Interactive comment on “Automated reconstruction of rainfall events responsible for shallow landslides” by G. Vessia et al.

Received and published: 9 July 2014

Fig. 1. Locations of the 100 shallow landslides considered in this study on the Italian territory over the period 2002–2012.

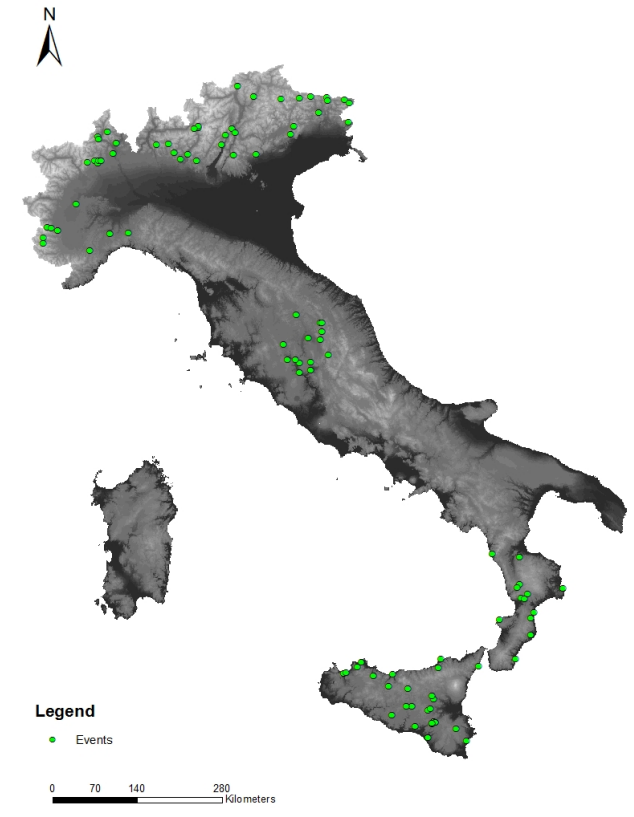
1) Introduction. Authors could preferably give more information about the dataset of 100 shallow landslides by means of a general description of geological and physiographic features as well as descriptive statistics of local bedrock lithology and morphological features of landslides (e.g. histogram for the bedrock lithology; box plots of mean slope angle, slope length, etc.). We accepted the suggestion, and we now provide additional information on the 100 landslide locations and distributions in Italy, including new Figure 5. However, we do not think that a detailed description of the geological and lithological settings for the 100 landslides is useful for this paper. The aim

of the paper is to show how predictive can the new automated method be, when applied to different climatic and physiographic conditions, without other parameters such as geology and morphology. Similarly, (D,E) pairs used to build the empirical rainfall thresholds worldwide by different methods do not take explicitly into account physiographic conditions. In our case, the 100 landslides are extracted from a database of more than 2000 events in Italy, considering different climatic conditions and elevations (see also Tables 1 and 2 below) (Koppen-Geiger system (1) Peel, M. C. and Finlayson, B. L. and McMahon, T. A. (2007). "Updated world map of the Köppen–Geiger climate classification". *Hydrol. Earth Syst. Sci.* 11: 1633–1644. doi:10.5194/hess-11-1633-2007. ISSN 1027-5606.) 2) Discussion. Besides the significant increase of the slope values for power law trends (D,E), descriptive statistics regarding differences among rainfall events identified by expert and automated procedures, in terms of cumulative rainfall, duration and average intensity, would give a better understanding about the performance of the proposed automated procedure. We maintain that the differences observed for the two trends are not significant. This is clear when the single 100 pair datasets are compared and discussed in Figs. 5a-f.
